# Service Campaign Bulletin

Campaign No. 2007060001, June 2007

SUBJECT: **MODEL 211, 216, 219, 221, 230**  
**MODEL YEAR 2007**  
**CHECK STARTER WIRING HARNESS ROUTING AND RE-ROUTE IF NECESSARY**  
**(M273 ENGINE)**

Figure 1

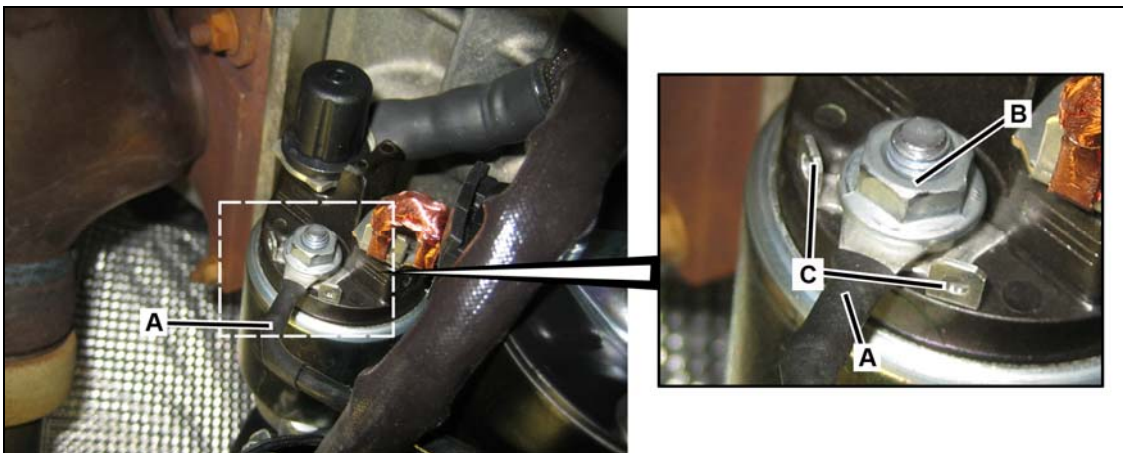
This Service Campaign has been initiated because DCAG has determined that on the affected vehicles it is possible that the routing of the starter wiring harness may not meet specifications. Failure of the starter, in isolated cases, may occur if this condition exists and is left uncorrected. Dealers will check the starter wiring harness routing and correct if necessary.

1. Raise vehicle on lift; refer to appropriate WIS document AR00.60-P-1000 based on vehicle model.
2. Remove center and rear engine compartment paneling.
3. Check insulation of starter wiring harness circuit 50 (A, Figure 1).
4. Perform one of the following, depending on results of step 3:
  - If insulation **is not** damaged: Perform Procedure B.
  - If insulation **is** damaged: Perform Procedures B and C.

4. Position starter wiring harness connector (B) as shown in Figure 1—between two metal tabs (C)—and reinstall M6 nut.
  - Torque nut to 8 Nm.
5. Reconnect battery ground cables, again referring to appropriate WIS document from step 1.
  - Perform basic programming.

1. Install heat-shrink tube (A, Figure 1) at electrical connector of starter wiring harness.
  - Use 3/8" (9.5 mm) wide, 1" (25 mm) long tube.

2. Position starter wiring harness connector (B) as shown in Figure 1—between two metal tabs (C)—and reinstall M6 nut.
  - Torque nut to 8 Nm.
3. Reconnect battery ground cables, again referring to appropriate WIS document from Procedure **B**, step 1.
  - Perform basic programming.

**Figure 2**

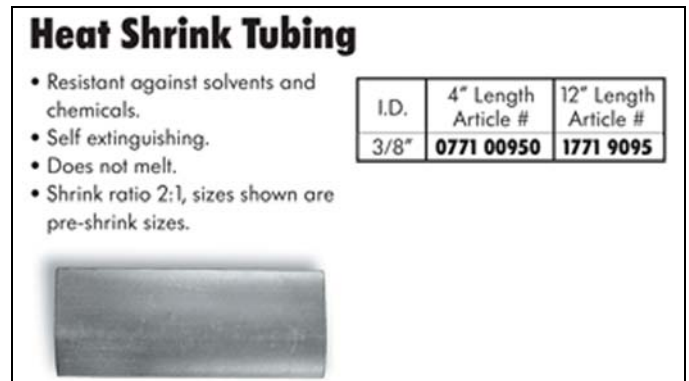
**The heat-shrink tube can be obtained from Wurth USA, Inc., (see Figure 2 for part number) or similar company.**
